**Entergy Operations, Inc.**  
P.O. Box 756  
Port Gibson, MS 39150  
Tel 601 437 2800

Subject: Grand Gulf Nuclear Station  
Docket No. 50-416  
License No. NPF-29  
Appendix J Exemption Request  
Response to Additional Information Request Dated June 10, 1994

GNRO-94/00099

Figure 1

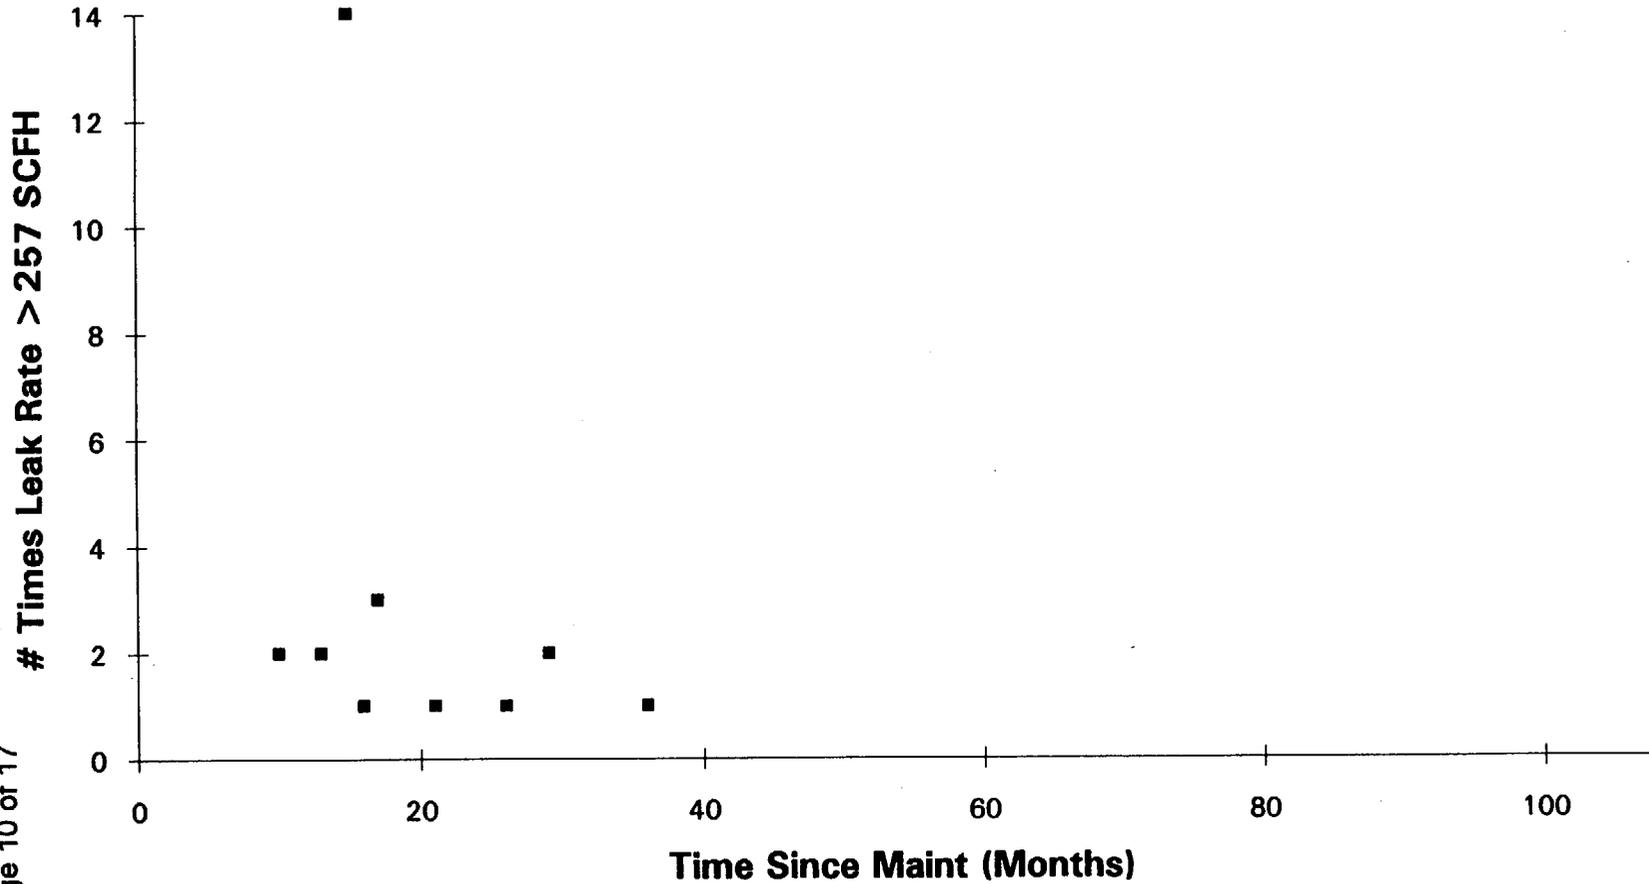
Figure A-7 on page A-35 of draft NUREG-1493, "Performance-Based Containment Leak Test Program," contains a plot showing the number of times a component with a leak rate of 257 scf/h or more was found versus time since the last maintenance of the component. The plot was generated using data from another power plant. The 257 scf/h corresponds to the highest detectable leak rate for that power plant.

Please provide a plot similar to Figure A-7 using Grand Gulf specific data and the maximum detectable leak rate for Grand Gulf.

The staff intends to use this plot as one indication of the suitability of the 5 and 10 year test intervals proposed by Entergy, Inc., for Grand Gulf.

Although performance data alone cannot be used to determine interval lengths, it can be used as confirmatory information in support of intervals - i.e., a check on the "reasonability" of the proposed intervals. For instance, using the approach of NUREG-1493 (Figure A-7), we can plot the frequency of relatively gross component leak rates (i.e., > 257 scfh) versus time since maintenance. Using Grand Gulf data which covers nearly a 10 year period (Figure 1) we find that large component leak rates peak approximately one refueling outage following maintenance. Thereafter, components with large leakage rates stay in the 1-2 range up to the second refueling outage following maintenance, and are non-existent after two refueling outages. The performance data support the proposed scheme of not allowing extended test intervals until two successful passed tests

The requested figure is included in the response to the previous question as Figure 1.

Months Until First Failure  
Figure 2

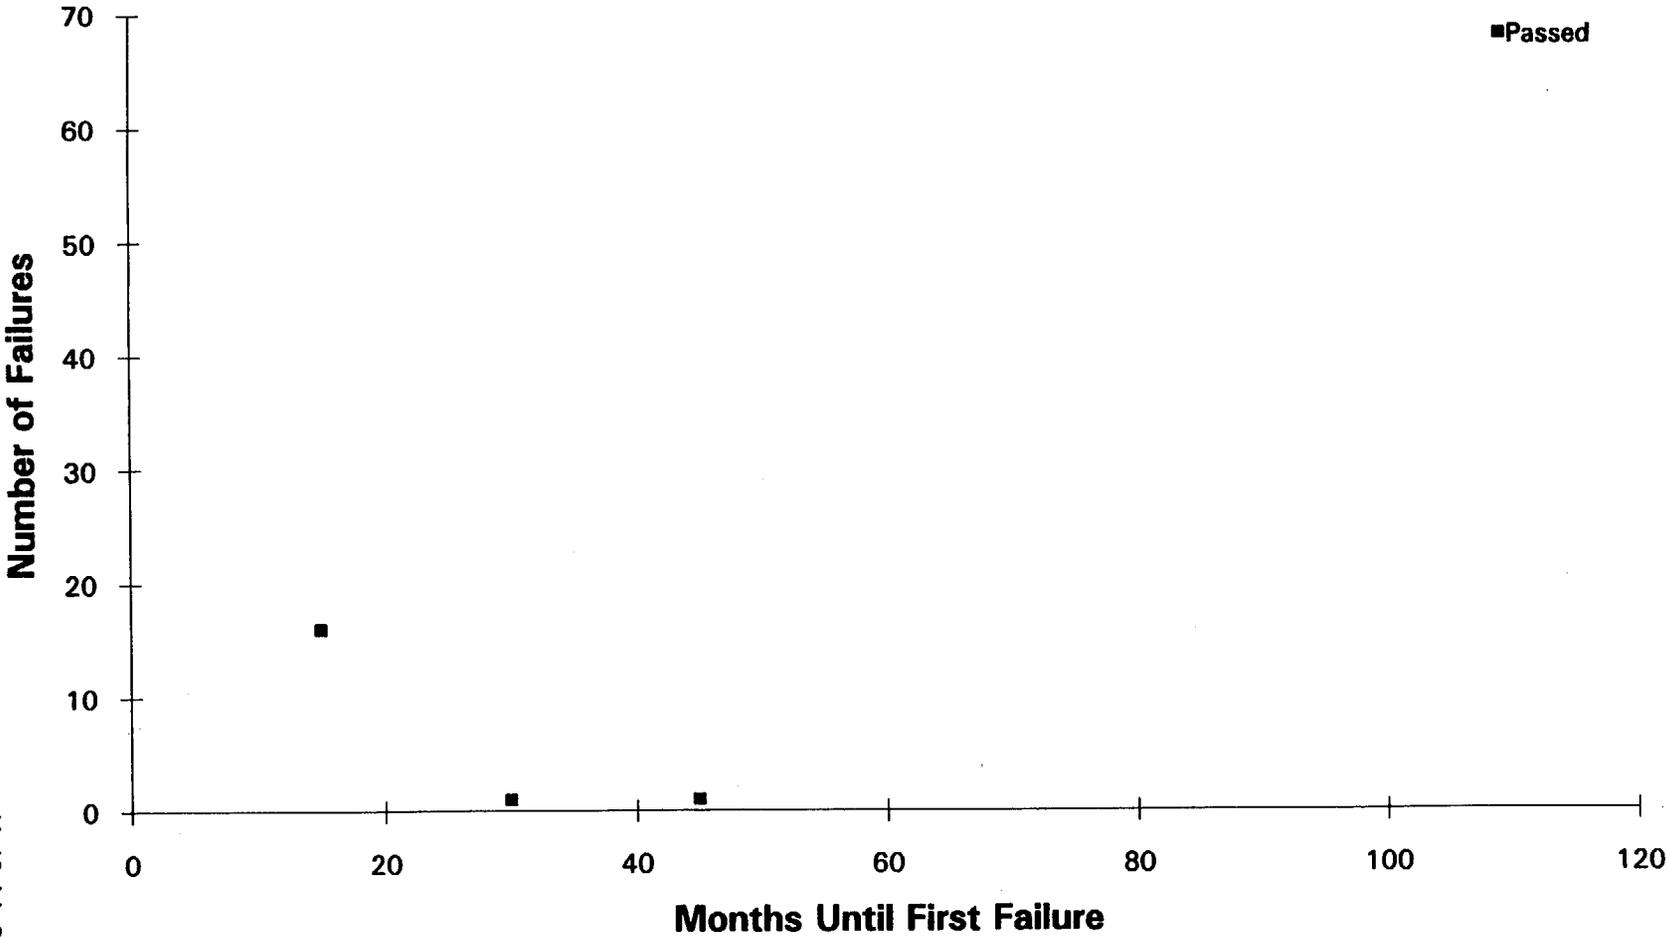
We do not consider this to adequately justify the specific 5 and 10 year intervals. Please provide a detailed analysis, using the data from past testing history, that demonstrates the acceptability of these intervals. State clearly what criteria are used to determine acceptability. Also, identify any data, not specific to Grand Gulf, that were used to justify the 5 and 10 year intervals.

- Figures 2 and 3 plot the period of time which elapses prior to a component's first failure for Type B and C components, respectively. In fact, most components have never failed in nearly 10 years of operation (represented by the point labeled "Passed"). Those few components which do fail to meet administrative limits usually do so within the first couple of refueling outages, a similar behavior to the grosser leakage failures presented in Figure 1.
- For components that have experienced a failure we can measure the effectiveness of corrective action by plotting the period of time which has elapsed without another failure occurring, for Type B (Figure 4) and Type C (Figure 5) components. As shown, most components stay "fixed" following a failure for an extended period of time.
